Illinois Tollway Base Sheet Revisions

Section M		Base Sheet Drawings	
Drawing	Modification Summary	Effective: 2020-03-01	
Pole Assembly (ITS)-Series 1000			
M-ITS-1000	Elevation Views Pole Mounted ITS Element Assembly		
	Use 1 1/2" stainless conduits for power and fiber to ITS Enclosure instead of 2". Corrected the MVDS mounting height on elevation details Use 1 1/2" stainless conduit for ITS Disconnect switch		
M-ITS-1001	General Notes Pole Mounted ITS Assembly		
	Note added on placement of battery enclosure		
M-ITS-1002	ITS Standard Foundation		
	Note added to use 12 ft helix foundation for slopes over 1:6		
M-ITS-1003	ITS Concrete Service Pad		
	Shows option for back-to-back mounted ITS enclosures.		
M-ITS-1004	Cabinet Wiring Diagram - ITS Pole Mounted Enclosure (Solar Powered MVDS) (2 sheets)

M-ITS-1004
SHEET 1 OF 2

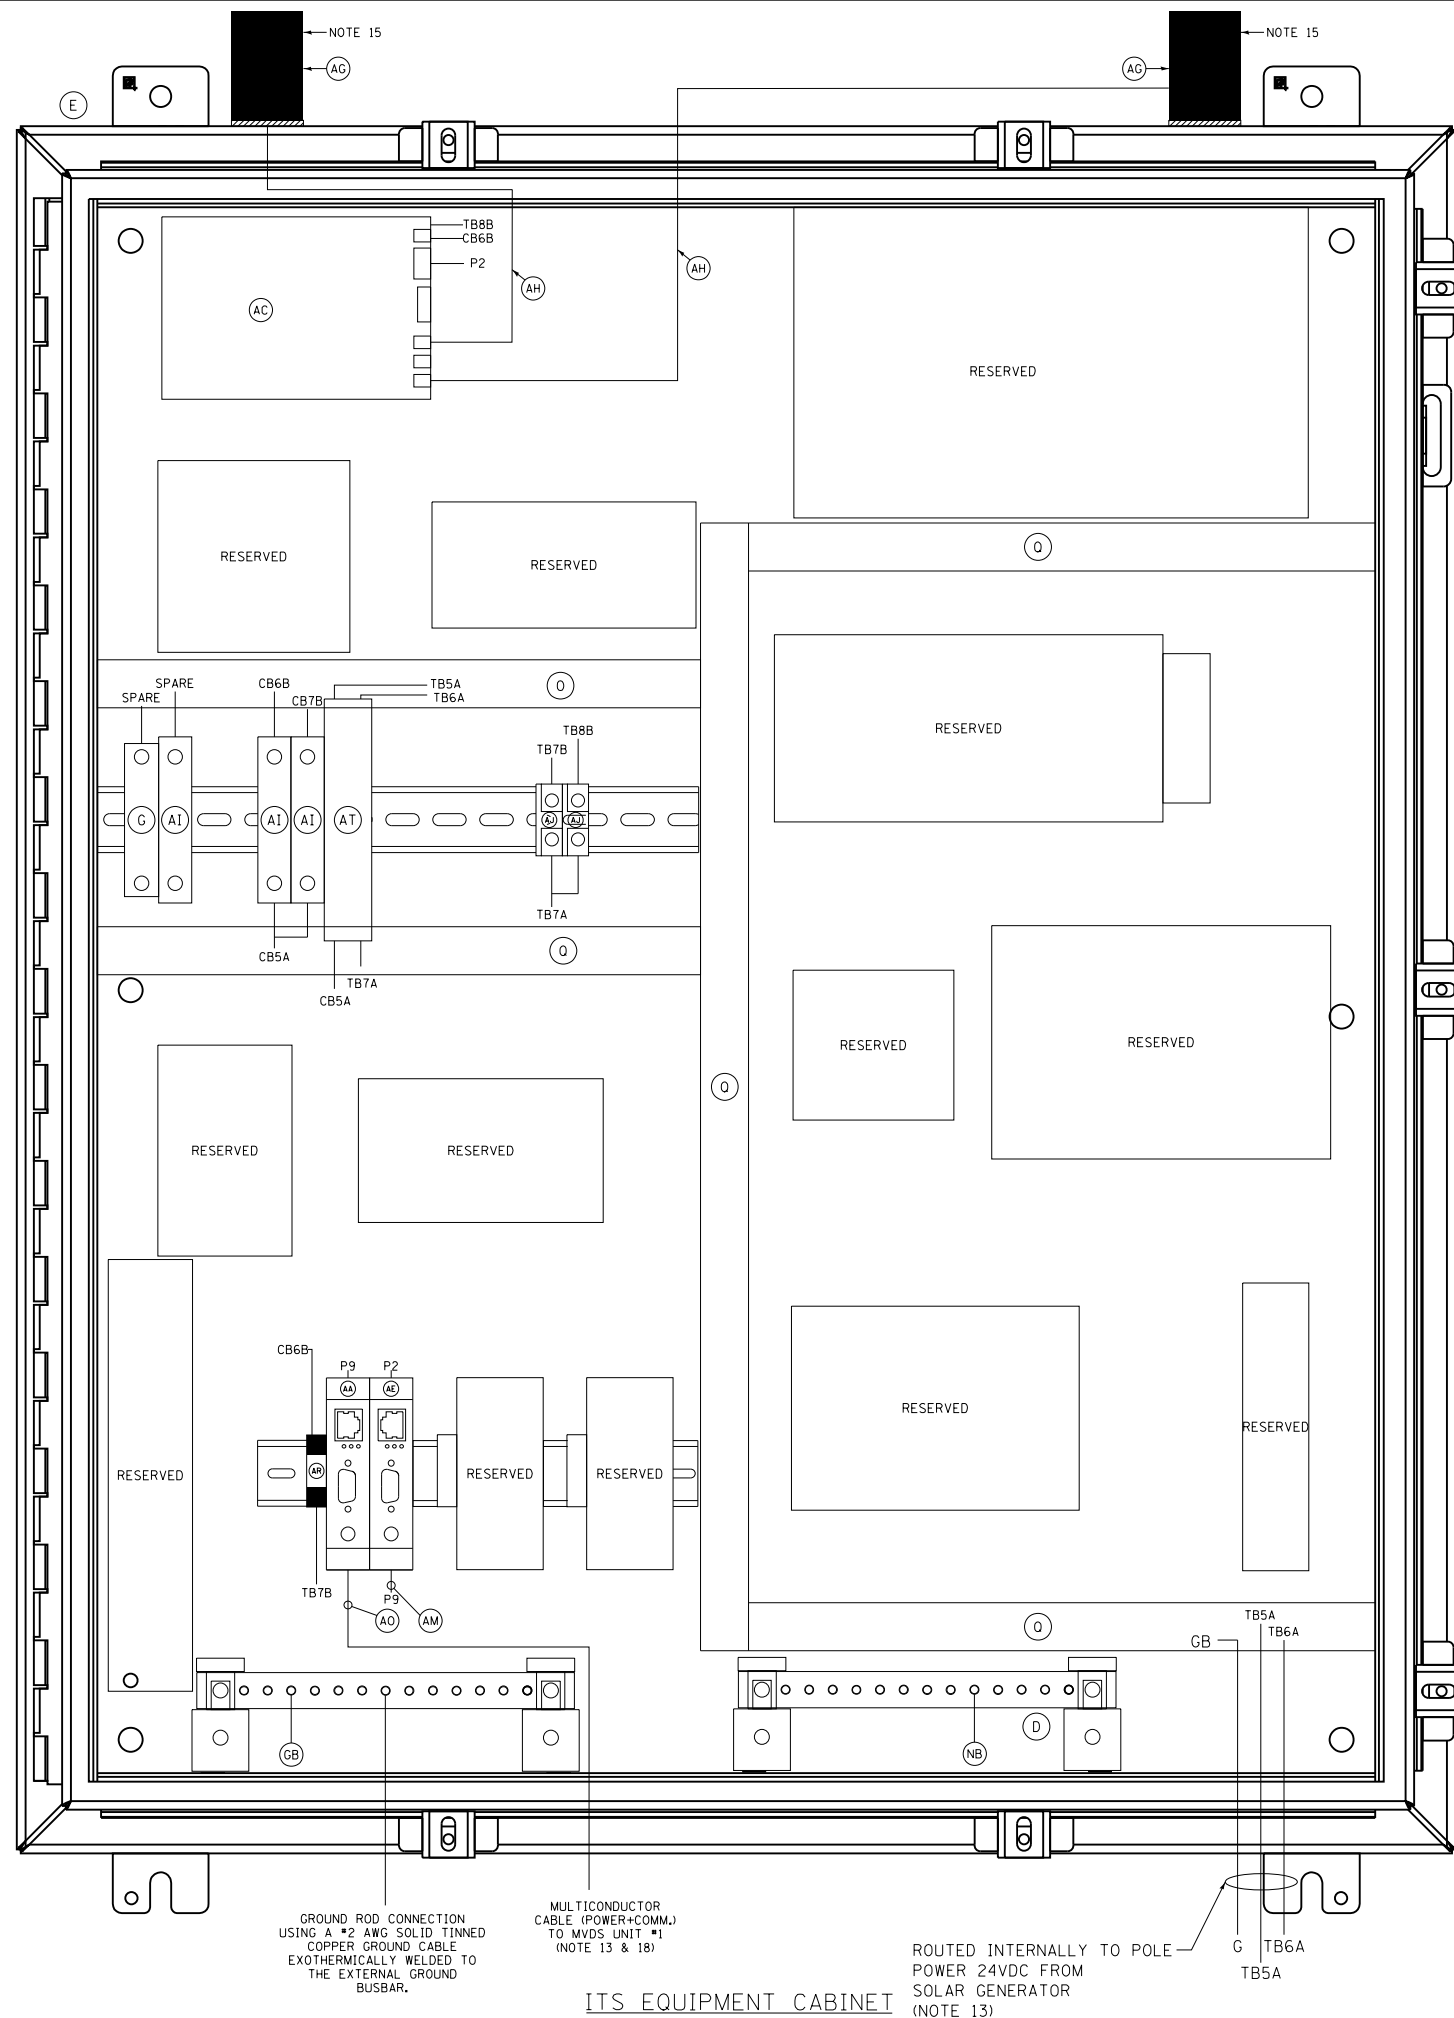
Sheet 1: Revised layout to better accommodate future expansion.		
Dynamic Message Sign (ITS)-Series 1100			
M-ITS-1100 to M-ITS-1108	DMS		
	(Typical) Revised Type 1 nomenclature to Walk-in (Typical) Revised Type 2 nomenclature to Front Access		
M-ITS-1101	DMS Type 1 Site Grounding Plan		
	Revised to show paved median structure		
M-ITS-1108	DMS Cabinet Wiring Diagram		
	Clarified wiring diagram Updated switch model		
Cabinet Wiring (ITS)-Series 1200			
M-ITS-1200 to M-ITS-1217	Cabinet Wiring Diagrams		
	New Cat6 surge suppressor Axis T8061 for Axis PoE camera and Ditek for Cohu PoE camera Revised layout for Cisco 4000 switch, power supply, Cohu PoE injectors Revised 1214-1216 plan to remove Cisco switch Added Level 3 Cisco license (L-IE4000-RTU=) Modified gator patch model number		
Roadway Weather Information System (ITS)-Series 1300			
M-ITS-1300	RWIS Pole, Sensor Mounting Detail		
	General note to have manufacturer to supervise installation and commissioning Revised to show option for co-located CCTV camera and ITS enclosure Clarified the mounting height measured from pavement surface Installed new ITS Enclosure back to back to the RPU enclosure Add ITS Disconnect switch within 50 feet from primary pole Show RWIS cabinet configuration for the 3 electrical services
